**Subject: MHI's Response to US-APWR DCD RAI No. 941-6465 Revision 3
(SRP Section 14.03.04)**

Response to Request for Additional Information No. 941-6465
Revision 3

US-APWR Design Certification

RAI NO.: NO. 941-6465 REVISION 3
SRP SECTION: 14.03.04 – REACTOR SYSTEMS – INSPECTIONS, TESTS, ANALYSES, AND ACCEPTANCE CRITERIA
APPLICATION SECTION: TIER 1 2.4
DATE OF RAI ISSUE: 5/21/2012

Figure 5.3-1 Orientation of Surveillance Capsules

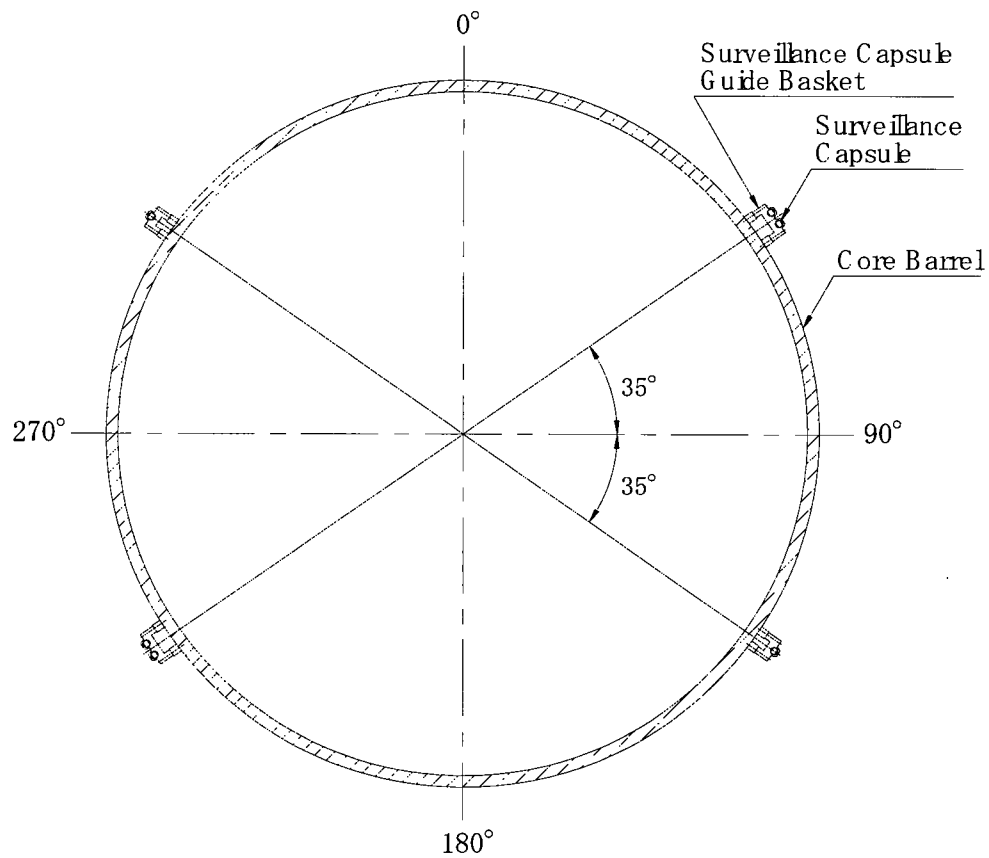
In Tier 1 Table 2.4.1-2, ITAAC 14, the ITAAC lacks sufficient details/specificity to assure successful completion (e.g. required location of the specimen guides on the RV).

DCD Tier 2 Figure 5.3-1 will be revised to clarify the design basis location of the four surveillance capsule guide baskets that hold six surveillance capsules.

The DD and DC of Tier 1 Table 2.4.1-2, ITAAC 14 will be revised to verify the surveillance guide baskets are attached to the core barrel and hold the surveillance specimens

- 1) Inspection to verify that four as-built surveillance capsule guide baskets are attached to the as-built core barrel in accordance with the design basis (i.e., as shown in DCD Tier 2 Figure 5.3-1), and
- 2) Determine that the surveillance capsules are in the locations required by the analyses and to inspect verify that the six as-built surveillance capsules are placed at the required location in the as-built surveillance capsule guide baskets.

13. Displays identified in Table 2.4.1-1 are provided in the MCR.
 14. ~~Irradiation specimen guides~~ Surveillance capsule guide baskets are attached to the core barrel to hold capsules with material surveillance specimens.
